<b>FEI CPCN APPLICATION FOR OKANAGAN CAPACITY UPGRADE PROJECT</b>	<b>EXHIBIT A-10</b>
---	---------------------

**Re: FortisBC Energy Inc. – Application for a Certificate of Public Convenience and Necessity for the Okanagan Capacity Upgrade Project – Project Number 1599152 – Information Request No. 3**

**INFORMATION REQUEST NO. 3 TO FORTISBC ENERGY INC.**

ITS - Historical Rate Schedule 1 UPC<sub>peak</sub>

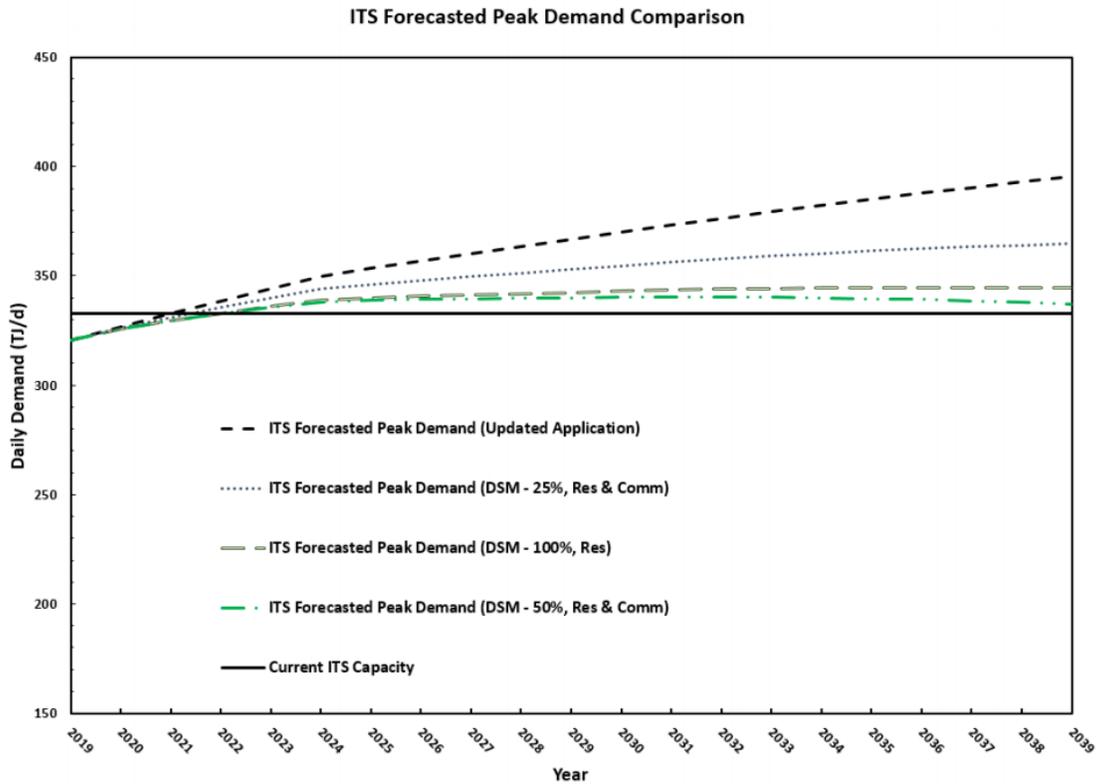
65.1 Please discuss whether FEI's position at this time is that historical UPC<sub>peak</sub> trends and values are the only relevant considerations for forecasting the UPC<sub>peak</sub>.

65.1.1 Please discuss whether FEI considers there are any circumstances where adjustments to the future UPC<sub>peak</sub>, on an annual or other basis, would be appropriate.

65.1.2 Please discuss how FEI's approach to calculating the UPC<sub>peak</sub> compares to other gas utilities.

65.2 Please confirm, or explain otherwise, that for the years 2017 – 2019 (i.e. the years after the adjustment to the system design temperature, which are used in the calculation of the peak demand forecast) there has been an annual reduction in UPC<sub>peak</sub> for all rate schedules.

65.2.1 Please describe how the proportion of reduction in the UPC<sub>peak</sub> compares to the proportion of annual energy savings from DSM programs in that time.

In response to BCUC IR 42.5.1, FEI provides the following figure showing peak demand forecasts with hypothetical savings from DSM measures:

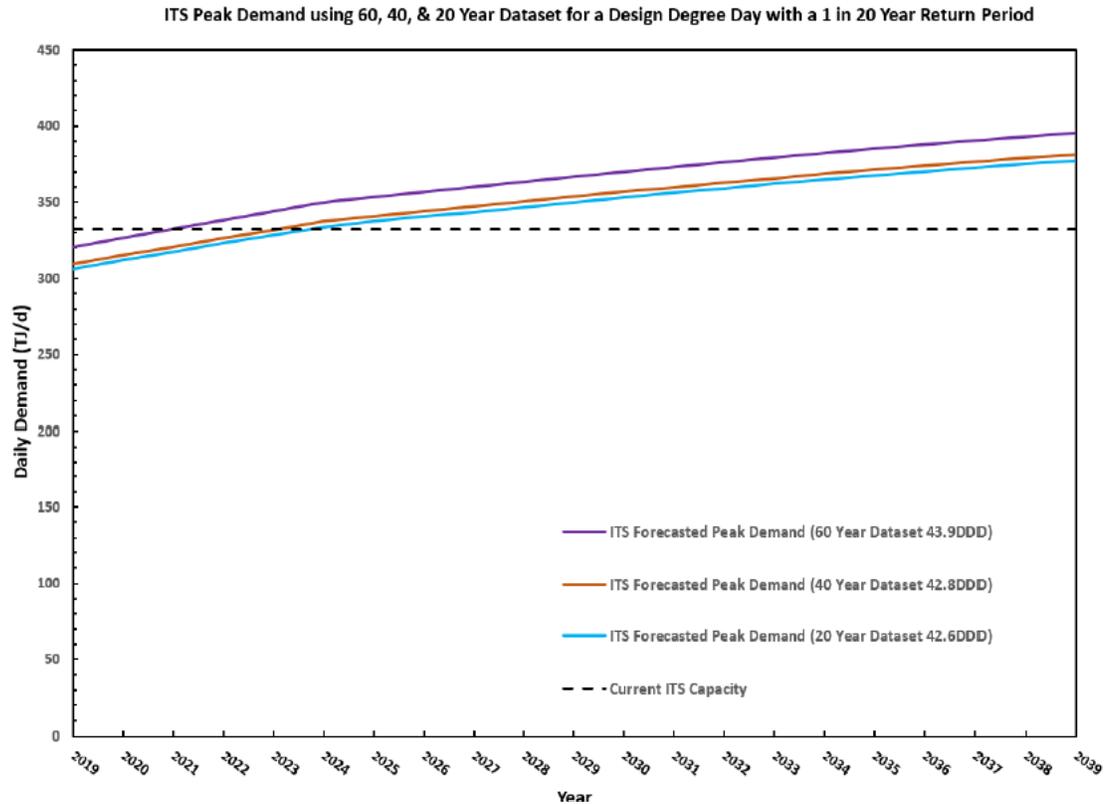
66.1 Please clarify whether in its response to BCUC IR 42.5.1, the line representing “DSM – 100% Res” is intended to represent residential and commercial customers.

66.1.1 If required, please correct the data in the figure and corresponding table to show the scenario with demand savings from commercial customers included.

In response to BCUC IR 43.2, FEI provides the ITS peak demand using a 60, 40 and 20 year dataset:

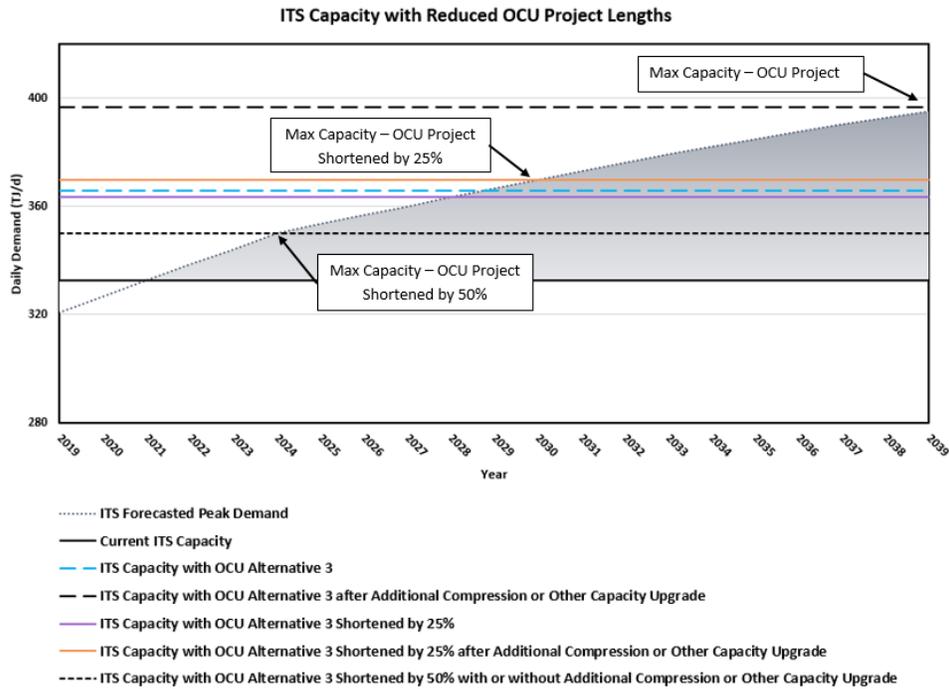
66.3 Please provide versions of the figures provided in response to BCUC IR 42.5.1 and IR 43.2 overlaid with the capacity of the alternatives outlined in the response to BCUC IR 50.1.

66.3.1 Please also estimate the length of pipeline that would be required to meet each of the peak demand forecasts outlined in BCUC IR 42.5.1 and IR 43.2.

In response to BCUC IR 26.4, FEI provides the following map showing the proposed route alignments for horizontal directional drilling (HDD) and open trench crossings of Penticton Creek.

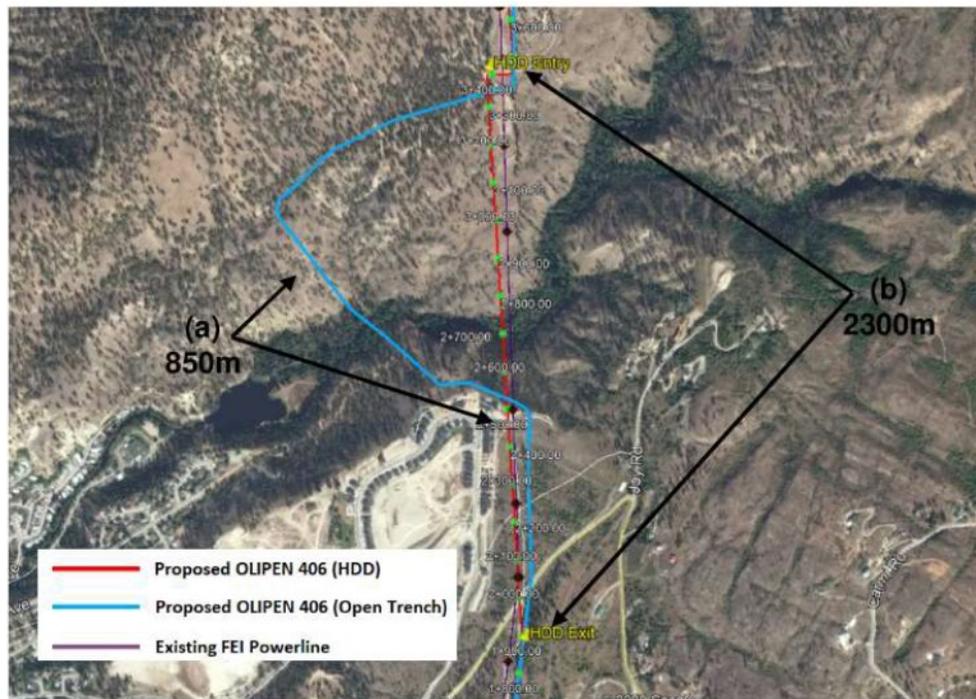
67.1 Please identify the bounds of the Penticton Creek crossing on the map provided in the preamble and explain how these boundaries were determined.

67.2 Please discuss whether FEI has identified any potential issues with the proposed route alignments for HDD and open trench crossings that may require a portion of the route alignment to be outside the identified bounds of the Penticton Creek crossing.

67.3 Please discuss whether FEI has identified any alternative crossing of Penticton Creek which is partially or fully outside the identified bounds.

67.3.1 If yes, please describe the alternative in detail and provide a map showing the route.
